Subject: Turkey Point Mandatory Hearing - Comments

Attached are comments received from the following in the matter of the Florida Power & Light Company, Turkey Point Units 6 and 7 (Mandatory Hearing), Docket Nos. 52-040-COL and 52-041-COL.

RE: DOCKETS 52-040 AND 52-041
Issuance of Combined Licenses for FPL's Turkey Point Units 6 and 7

**THE CITY OF MIAMI’S (“CITY”) STATEMENT OF ISSUES OR QUESTIONS
FOR CONSIDERATION BY THE UNITED STATES NUCLEAR REGULATORY
COMMISSION AT THE EVIDENTIARY HEARING IN THE UNCONTESTED
PORTION OF FPL’S COLA FOR TURKEY POINT UNITS 6 AND 7**

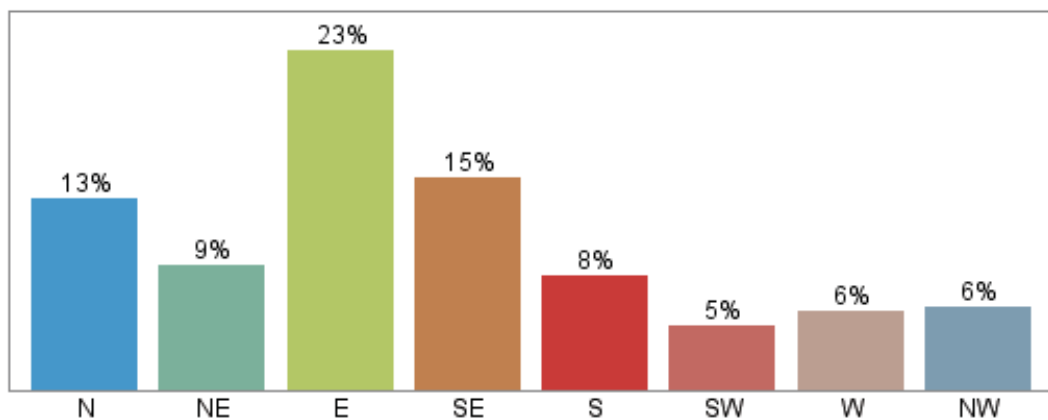
These statements in the Final EIS for TPN 6&7 not only lack documentation for the dominant wind directions, they are factually incorrect. The EIS indicates that winds blow “*generally to the southwest*”, which in meteorological parlance would be northeast winds. If that were true, then the subsequent statement would also be true, that we should expect “**lower depositional rates... in surface-water habitats near the site (e.g., Western Areas/Model Lands)**”. In Southeast Florida, winds blowing toward the SW (i.e., from the NE) are uncommon, as indicated in Figure 2 below. NE winds constitute only 9% of the yearly wind direction total, as indicated from wind data collected at nearby airports over decades.

Thus, actual data show that dominant winds in the region are toward the west and northwest (from the East and Southeast), which would relocate cooling tower chemicals offsite and deposit them in the Southeastern Coastal Everglades habitat west of Turkey Point.

As a consequence of factual misinformation incorporated into the EIS, careful and accurate consideration of the consequence of chloride and other chemicals misted across the coastal Everglades has been left out of the EIS. Effects of chemical deposition on freshwater wetland habitat must be addressed because of the acknowledged importance of the Coastal Everglades restoration. Until then, the EIS document is both inaccurate and incomplete.

Figure 3. Future flooding of major roadways in Miami-Dade County. *South Florida Climate Change Vulnerability Assessment and Adaptation Pilot Project*
https://www.fhwa.dot.gov/environment/climate_change/adaptation/resilience_pilots/2013-2015_pilots/south_florida/final_report/south_florida_final.pdf

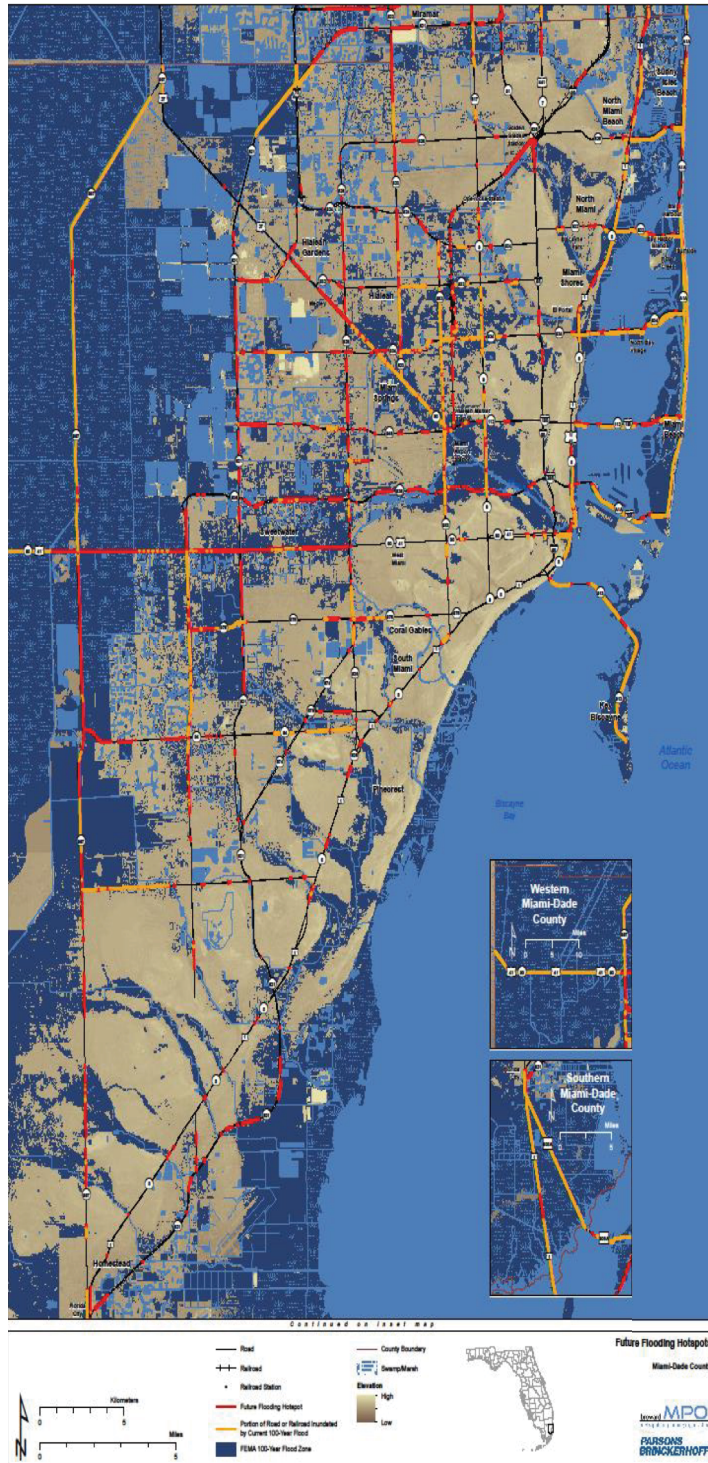
The U.S. Department of Transportation has determined that sections of local highways can be rendered impassible by storm flooding, the magnitude of which will be enhanced by sea level rise. Of particular concern for the COL application, every major road listed in the emergency evacuation plan for TPN 6&7 (*Turkey Point Turkey Point Nuclear Power Plant Evacuation Time Estimate report*), is among the roads that USDOT lists as being compromised by future flooding (shown in Figure 3 below), specifically Florida’s Turnpike, US-1, and Krome Avenue. From the ETE report (9-2):

The likelihood of evacuation is greatest following a hurricane, which is, not coincidentally the most likely driver of flooding and impassible road condition. Again, the problem identified is an interaction between known factors, each of which was considered separately in the COL application, but not together. An emergency evacuation time estimate cannot be considered complete if it does not account for likely complications resulting from the interaction between surface transportation and local flooding.

While building pads are proposed for elevation, access roads and roads on FPL property at Turkey Point are closer to sea level. Low elevation presents evacuation and access barriers in emergency situations when roads are inundated due to storm surge, the frequency and extent of which will be enhanced by sea level rise. We have seen no evaluation of the hazards posed by road flooding for emergency servicing of equipment or decommissioning.

Figure 4. The dark blue area inland of Turkey Point will be inundated by one foot of sea level rise. The existing cooling canals are seen in the center of the map.

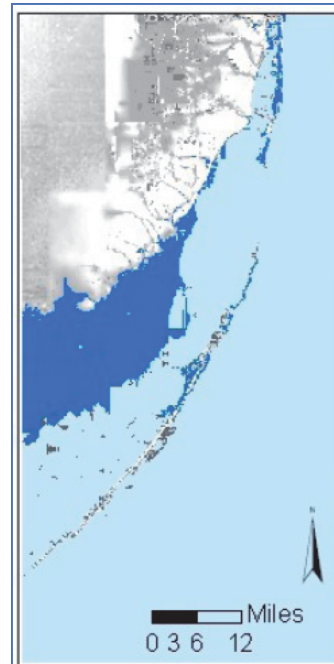
Many aspects of the COLA were predicated on a negligible 1-foot of SLR by 2100'. That projection was based on retrospective data from the last century, and not on prospective climate models for the current century. This projection was unrealistic when it was proposed, it has been proven to be wrong by data from the past two decades, and nowhere in the COLA is a consideration of which safety design assumptions are vulnerable to far greater acceleration of the rate of SLR as projected by NOAA. Formal consideration of worst-case SLR projections needs to be included in the application as advised by the White House CEQ and the Southeast Florida Regional Climate Compact. The COLA should include appropriate modeling for those worst-case SLR scenarios and accommodation of those projections in the safety design of TPN 6&7. Until realistic considerations of SLR are included in the application, the application should be considered incomplete from the perspective of long-term reactor safety.
